DRAWINGS AND DESCRIPTION OF PROPOSED CHANGES

UPPER FLOORS - THIRD TO SIXTH FLOOR

- any scaling from this drawing other than by the local planning authority solely for the purposes of the planning application to which it relates	
LOCATION	
job title	
TOTTENHAM HALE CENTRE	
ISLAND SITES

drawing title / location	
PROPOSED L03-06 FLOOR PLANS	
drawn by	checked
MG	AM
scale	status
1 : 250@A1, 1 : 500@A3	FOR APPROVAL
drawing number	revision
TH-IS_ZZ_001_A_16092_(P00)_P103	P04

3.4 BUILDING 1 UPPER FLOORS - THIRD TO SIXTH FLOOR

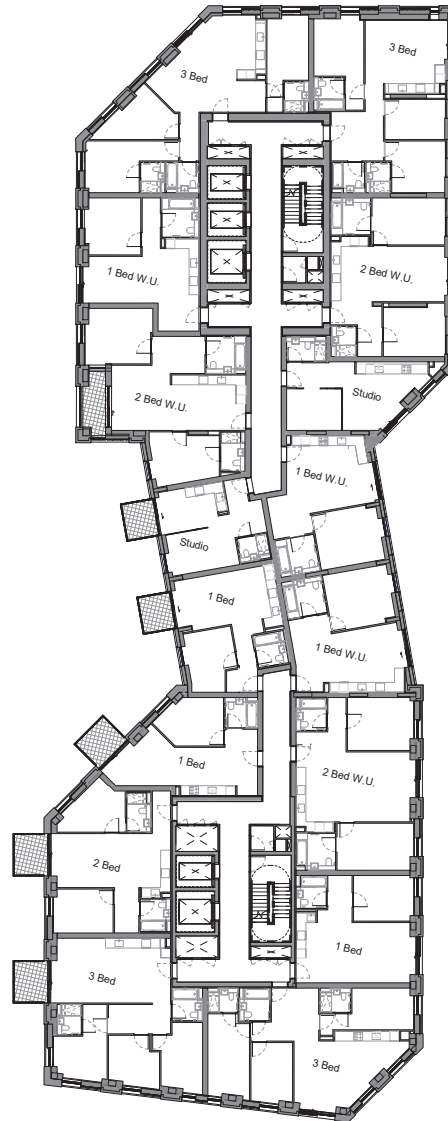
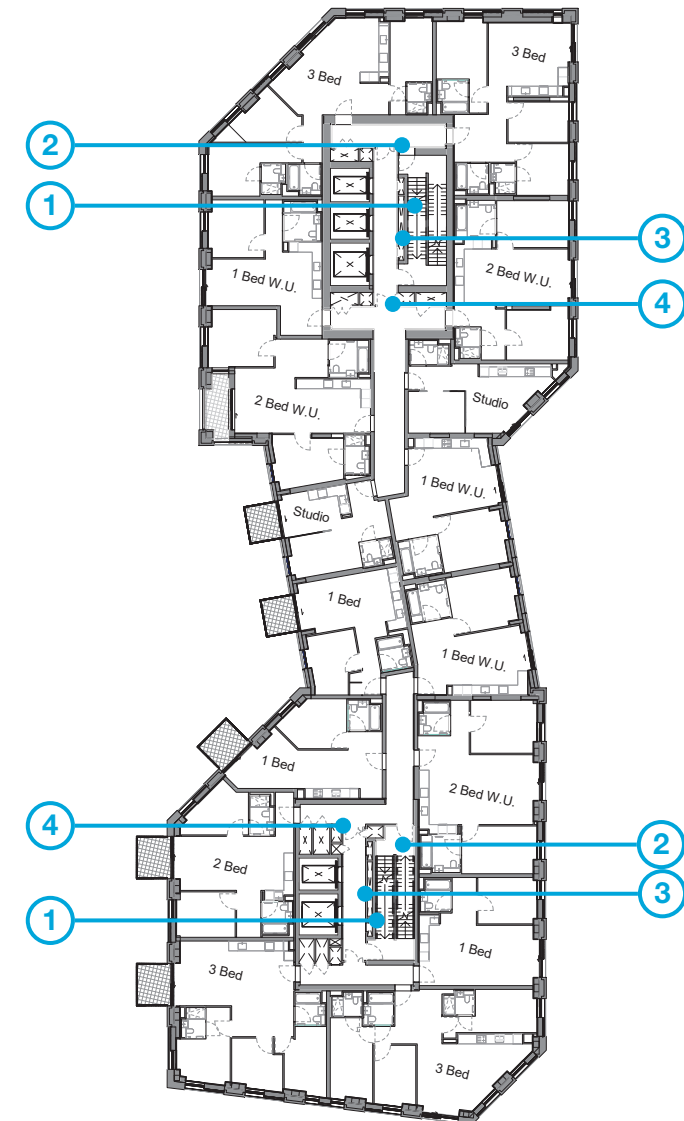
1. A second fire escape stair has been added between ground floor to upper levels.
2. Due to the addition of the second stair, the position of the access to the stairs has changed to resolve level changes across all floors.
3. Service risers have been relocated within the core following the addition of the second staircase.
4. Additional doors have been added within the communal corridors to comply with the latest fire strategy.
